**ON-SITE SEWAGE DISPOSAL SYSTEM
HOWARD COUNTY HEALTH DEPARTMENT
BUREAU OF ENVIRONMENTAL HEALTH**

SUBDIVISION: Waterford Farms

LOT NUMBER: 30

ADDRESS: 15916 Willis Way

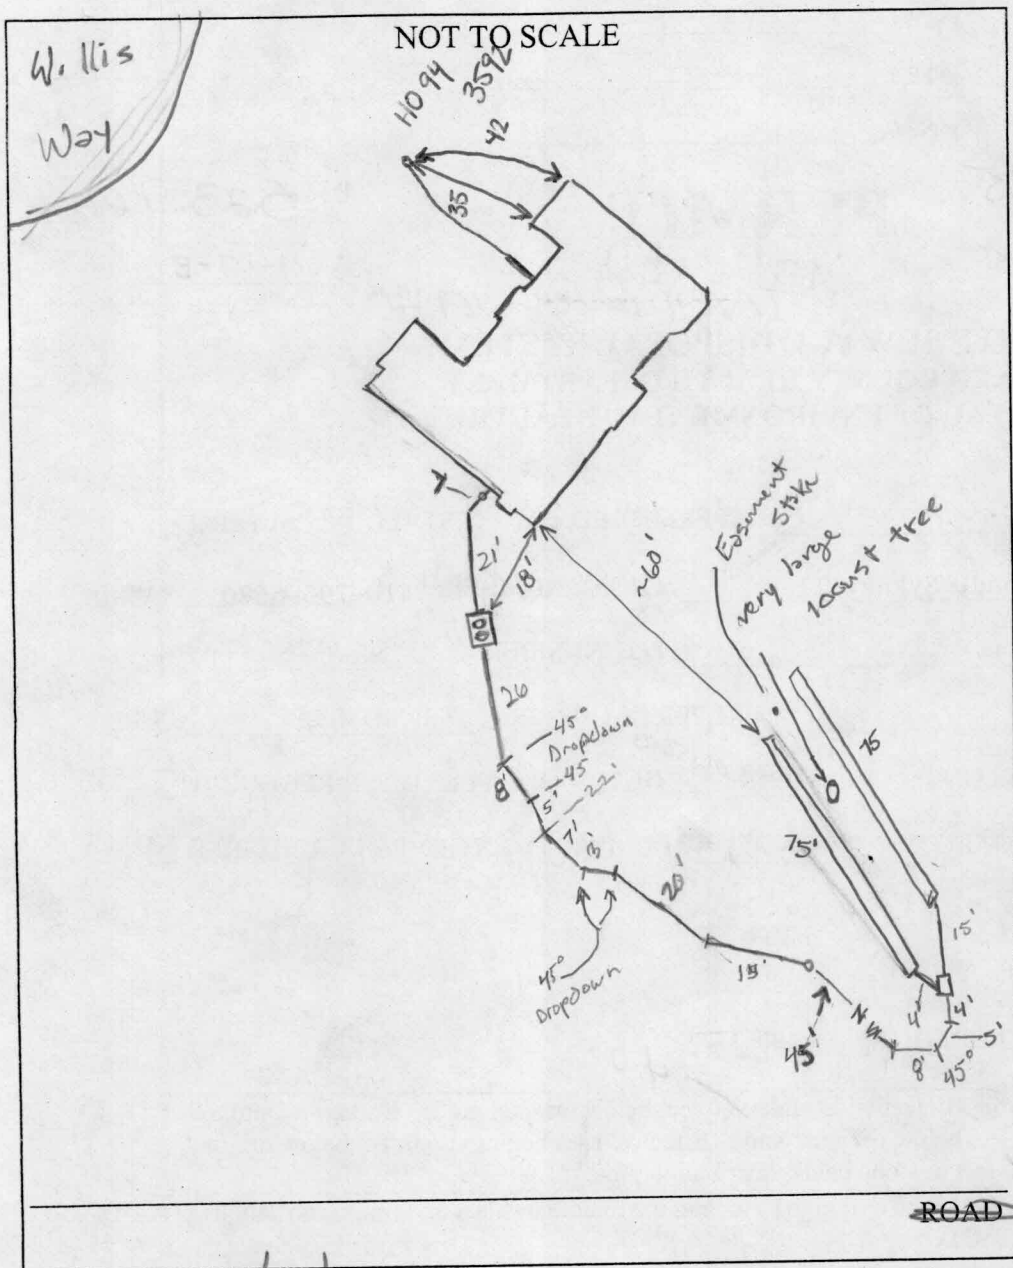
PRE-CONSTRUCTION 8/11/05 2x 75' trenches on contour along topographically upper part of the easement shorter section also at top will be lost due to bad contour.

INSTALLATION Ok to be slightly out of area to miss large tree and gain some better contour. (GAC) 8/12/05 Trenches are installed and ok Okay to cover ends of trenches ~ 10' from bottom of dramatically graded slope behind house. (GAC)
